Ref: BLM1219

## PLAN CHANGE 190061 – Darfield

## Appendix A: Proposed water take in relation to ODP

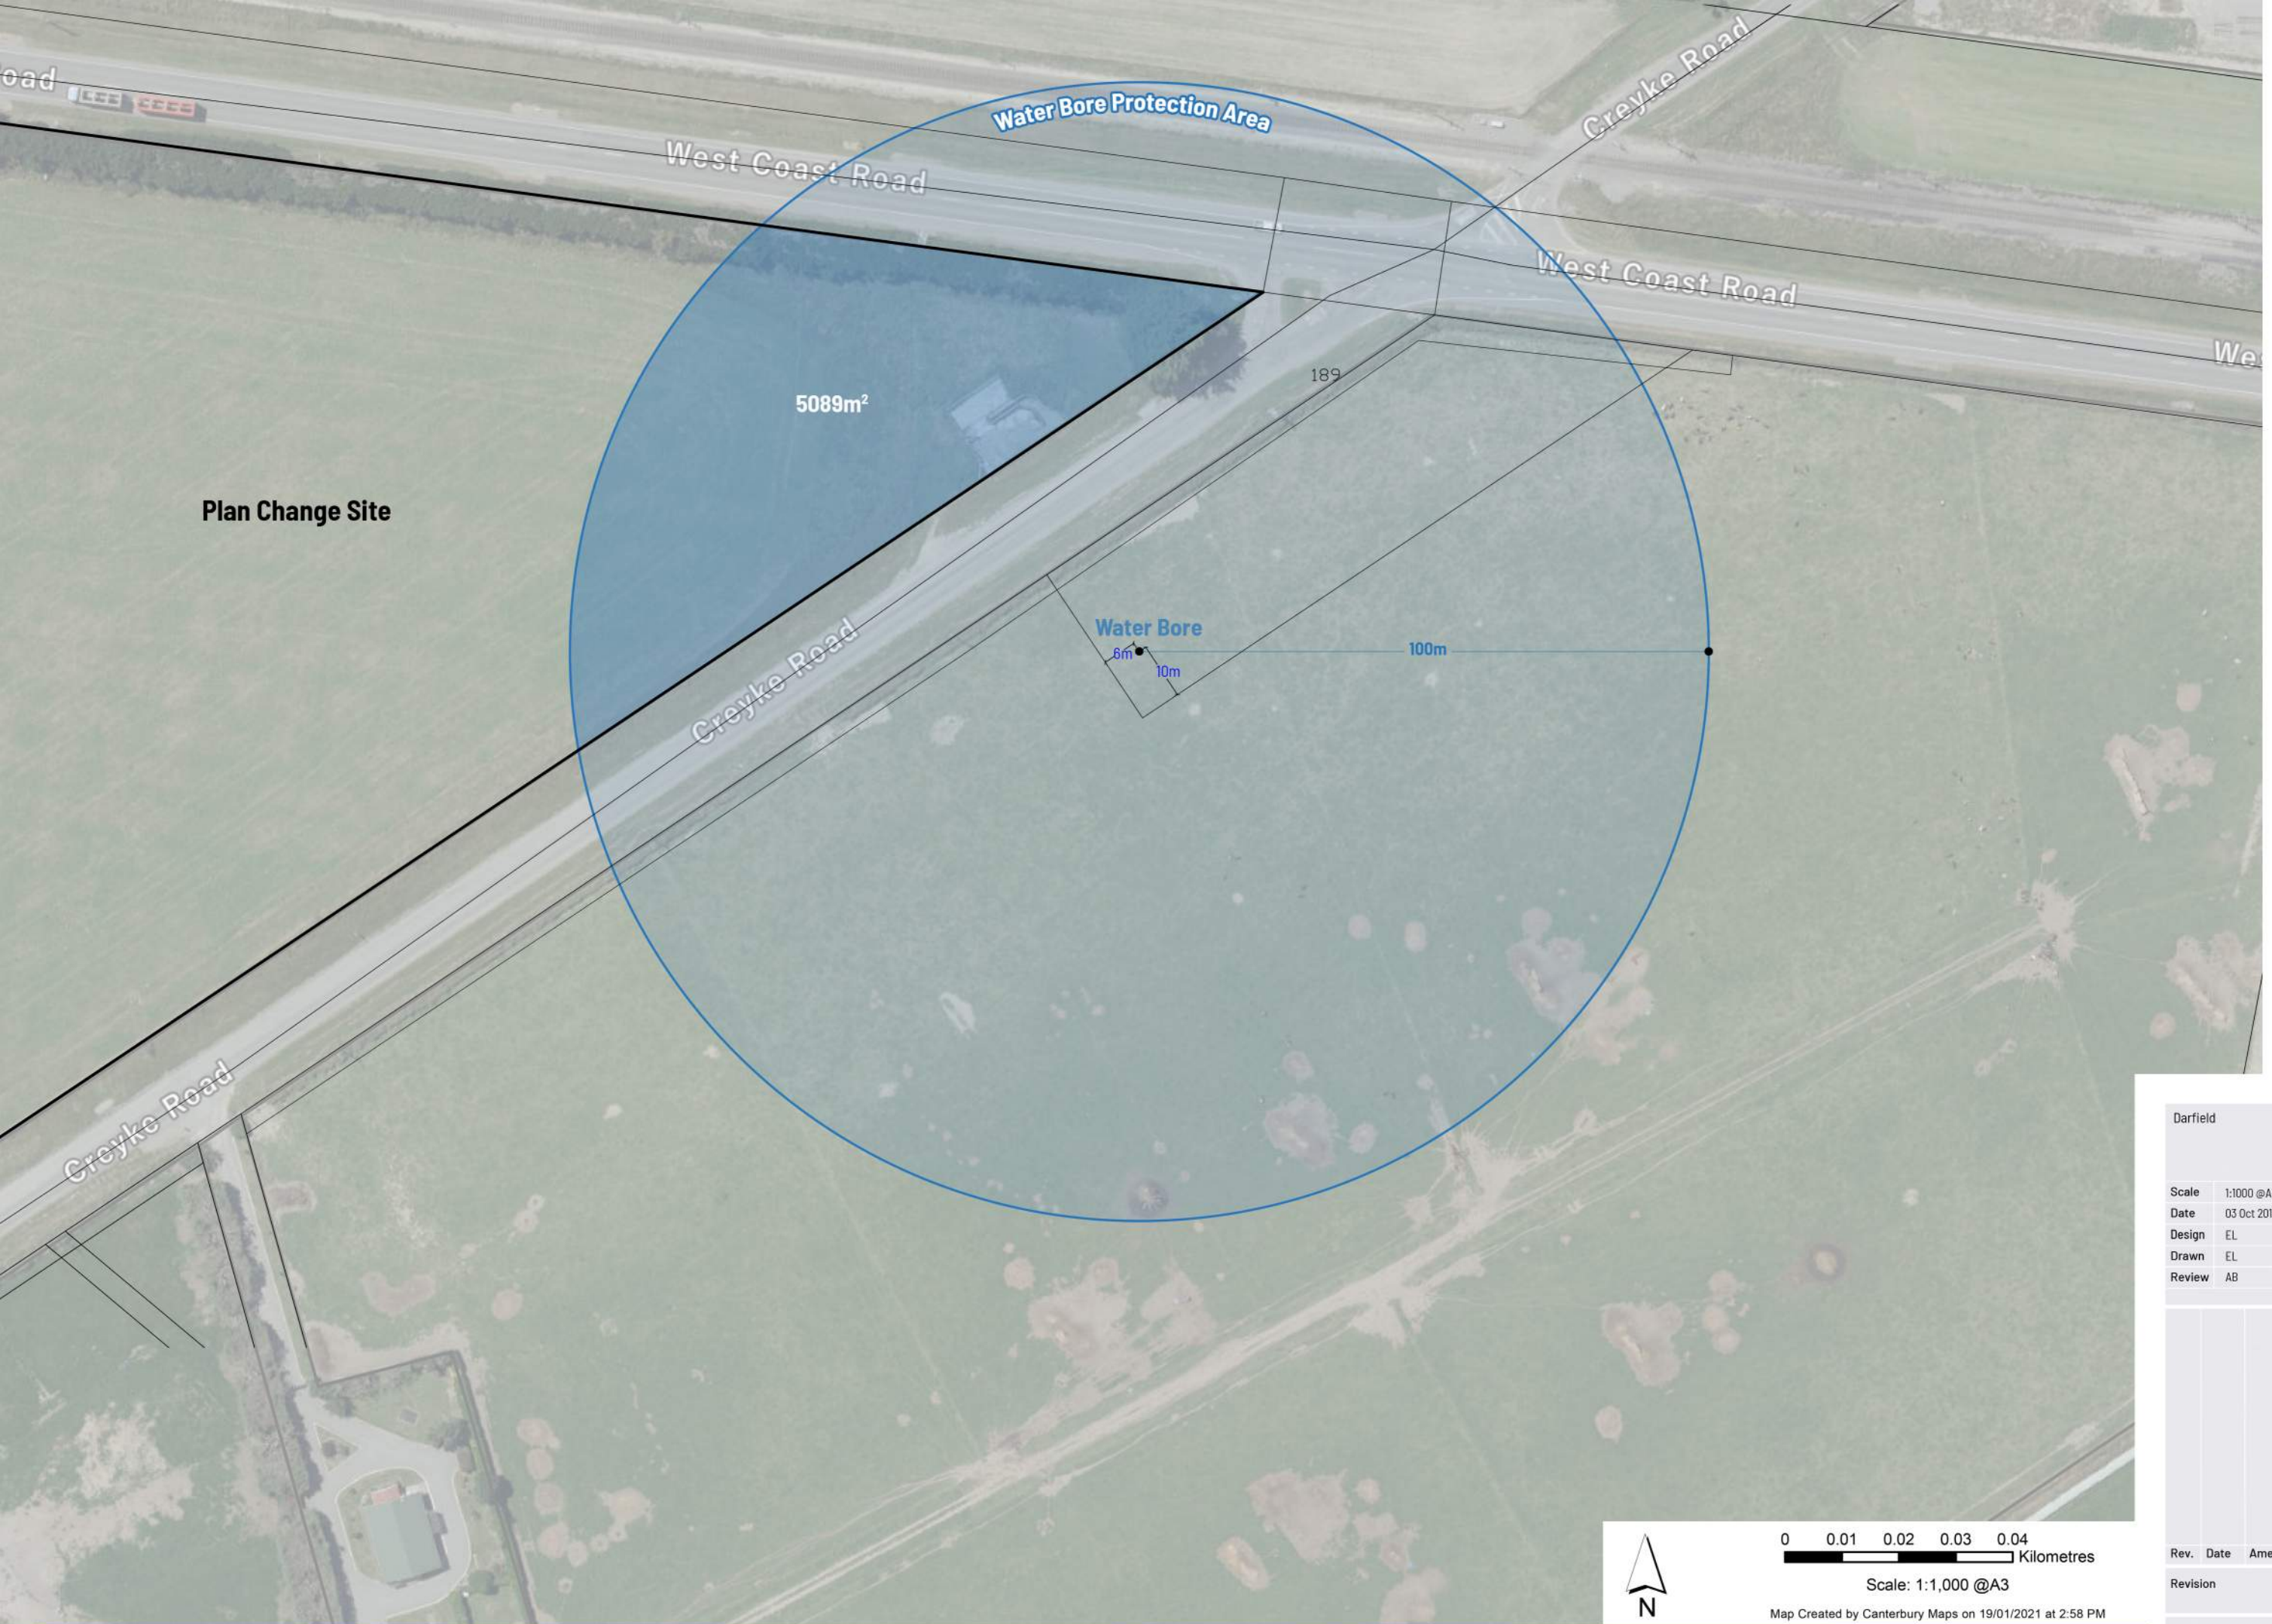
*Council is in the process of drilling a new community water supply bore on land it owns on the south side of Creyke Road. The application confirms the need for a new water source within, or in the area of, the proposed Plan Change. The new bore will require a 100m radius ground water protection zone. Please comment on the feasibility of the protection zone being shown on the Outline Development Plan. A plan showing the location of the bore being drilled is attached. Please contact Murray England Asset Manager Water Services for further information.*

The proposal sets out that additional water supply for Darfield to accommodate this development is required, so confirmation from Murray England this is going ahead supports the proposed plan change servicing requirements. The proposed location of the new infrastructure is shown in relation to the proposed outline development plan in Appendix A attached. This shows that the Council water take will have a 100m ground water protection zone across part of the application site that is proposed to be both road reserve and a small area of the proposed Business Zoned land.

Ground water protection zones are affected by stormwater discharges to ground and onsite wastewater disposal to ground. Ideally the application site will be serviced by reticulated sewer in conjunction with Council infrastructure upgrades as noted above, meaning that on-site wastewater disposal is not required.

It is anticipated that, as a source of community drinking water supply, there will be a groundwater protection area of 100 m identified in Schedule 1 of the Canterbury Land and Water Plan. Any future wastewater discharges or stormwater discharge will not be able to occur within this without obtaining a resource consent under Rule 5.8, or Rule 5.94A of that plan. Therefore, any effects on the community drinking water will be avoided.

As the proposed Plan Change area which includes part of the likely ground water protection zone is only within the proposed road reserve and business zone any future development will need to consider stormwater solutions that achieve Regional Council resource consent or are outside the exclusion zone. The small scale of this ground water protection zone within the application site means onsite solutions outside of the zone are feasible. Specific details of the location and nature of discharges will be determined at either resource consent or building consent stages.
